MassWildlife was contacted in an email from you on March 9, 2026, regarding the Low Impact Hydropower Institute's (LIHI) application by the Chicopee Falls Project (P-6222), located on the Chicopee River, Massachusetts. Following discussion internally at MassWildlife and with federal partners on the Technical Committee of the Connecticut River Migratory Fish Restoration Cooperative (CRASC), we have the following responses to your questions regarding American eel on the Chicopee River.

Figure 1. The range of American Eel in the Chicopee River Basin (MA), based on electrofishing samples from 1984 to 2024, from MADFW (Map sourced from USFWS draft GIS).

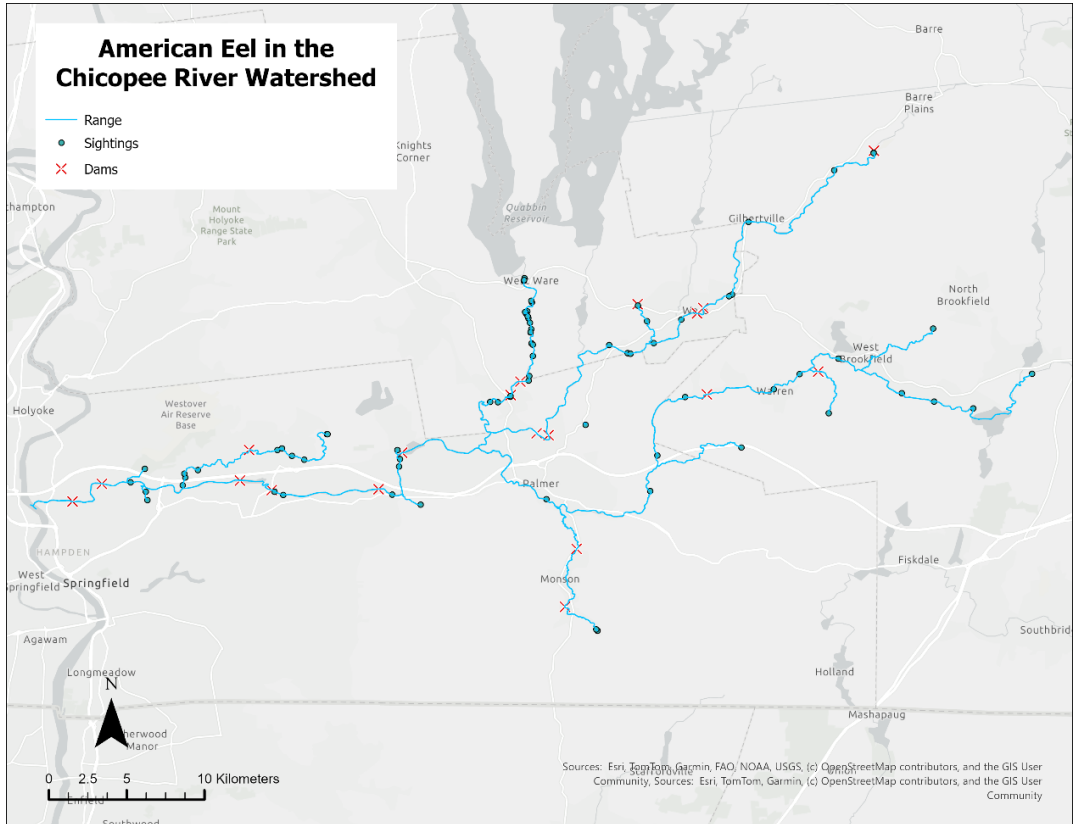
1) *What is the status of American Eel in the river? Are you aware of eel populations there? There have been prior anecdotal reports. If so, can you quantify the populations?*

Response – In the last decade, MassWildlife has completed 65 different fisheries surveys in the Chicopee River and its surrounding watershed. These surveys have documented American eel throughout the Chicopee River basin and areas upstream of the Chicopee Falls Project. This data was used in coordination with CRASC to develop the Connecticut River American Eel Management Plan (2023), outlining American eel occurrences in the watershed and agency-based management recommendations (Figure 1). This dataset provides evidence of an extensive range distribution in the Chicopee River basin by American eel. Despite these sampling efforts, quantifying American eel populations is challenging due to their preference for nocturnal activity and cryptic nature, reducing their detectability during traditional fisheries sampling. Upstream passage structures (eel ramp with holding tanks) at dams can be used to estimate populations but currently do not exist in the Chicopee River.
